# Advanced LIGO Engineering Change Request (ECR)

**ECR Title: Modification of Oplev/Pcal Receiver Pylon Weldments**

**DCC No: E1300594-v1**

ABOVE: D1300499-v2 Pcal Receiver Mounting Blocks shown in place (to be welded) on an X-Arm pylon weldment D1001297. On Y-Arm pylon weldments D1001292, the arrangement is similar by symmetry.

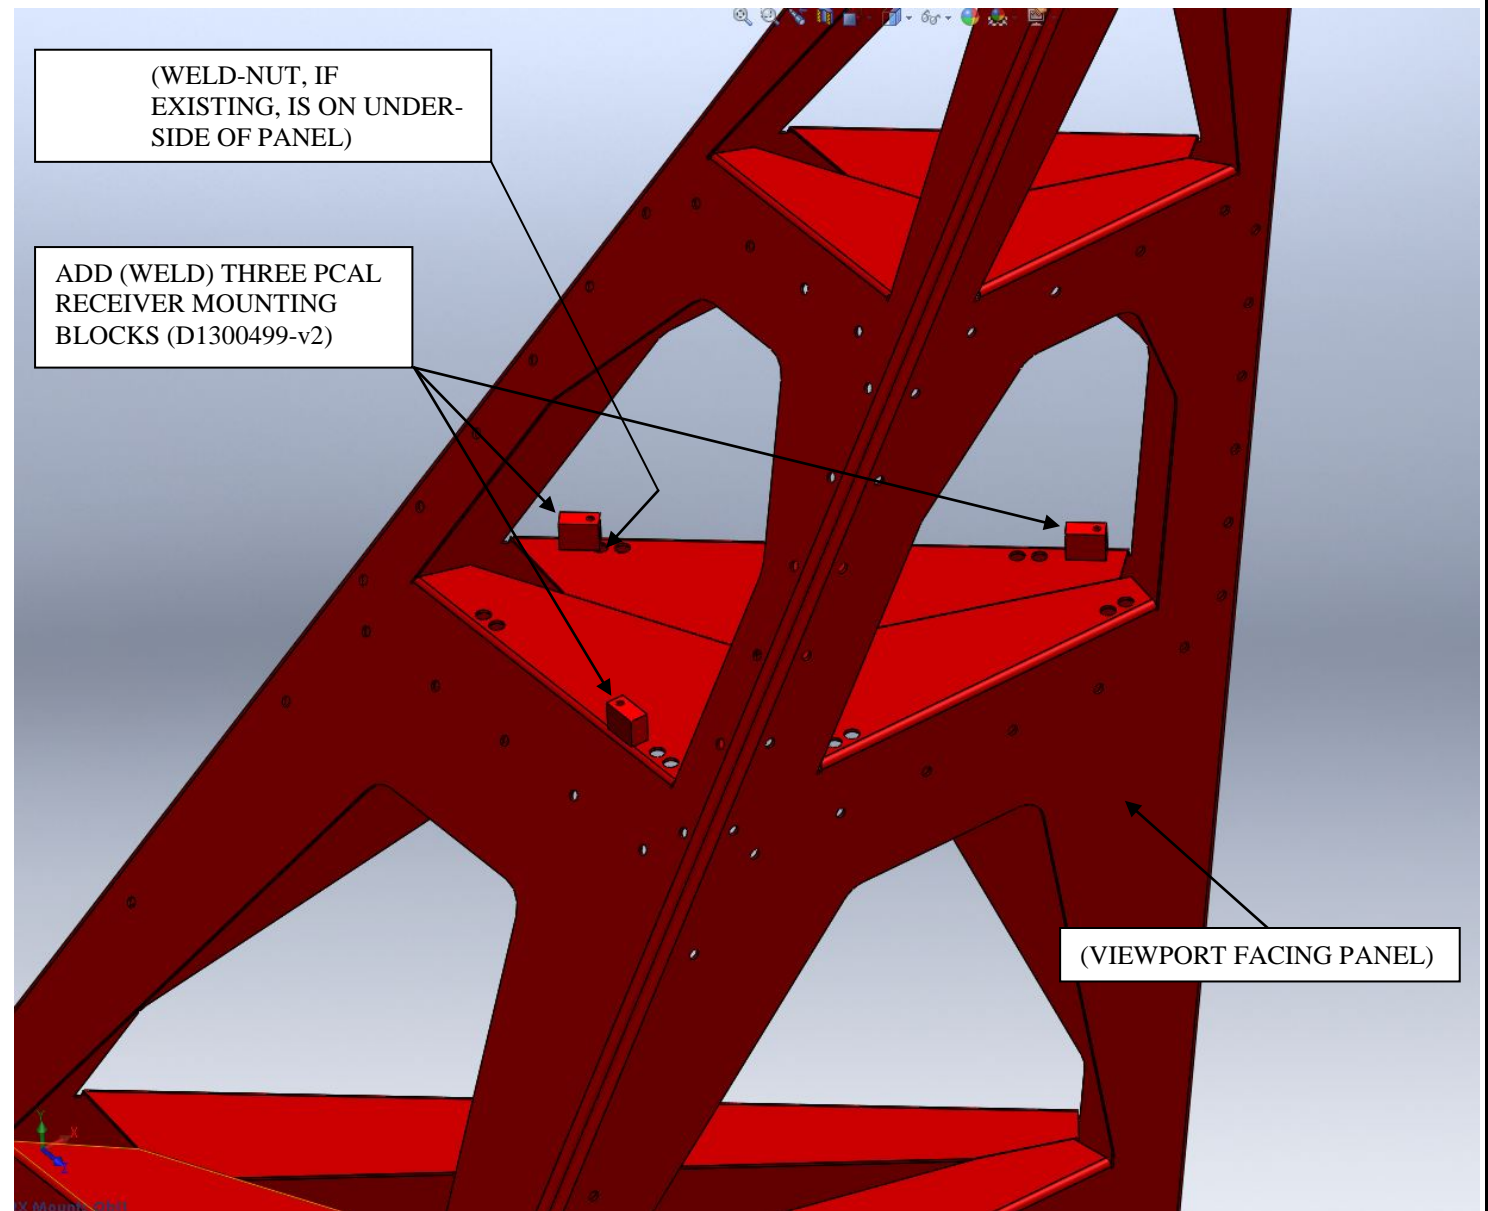
**Description of Proposed Change(s):** Addition of welded Pcal Receiver Mounting Blocks to Oplev/Pcal Receiver Pylon Weldments as follows.

**Reason for Change(s):** Due to absence on the Oplev/Pcal receiver pylons of any attachment means for the Pcal receiver module, the mounting blocks D1300499-v2 were designed to be welded at three specific locations (as shown above) to facilitate a three point push-pull type mounting arrangement, adjustable for leveling and elevation, for the receiver modules.
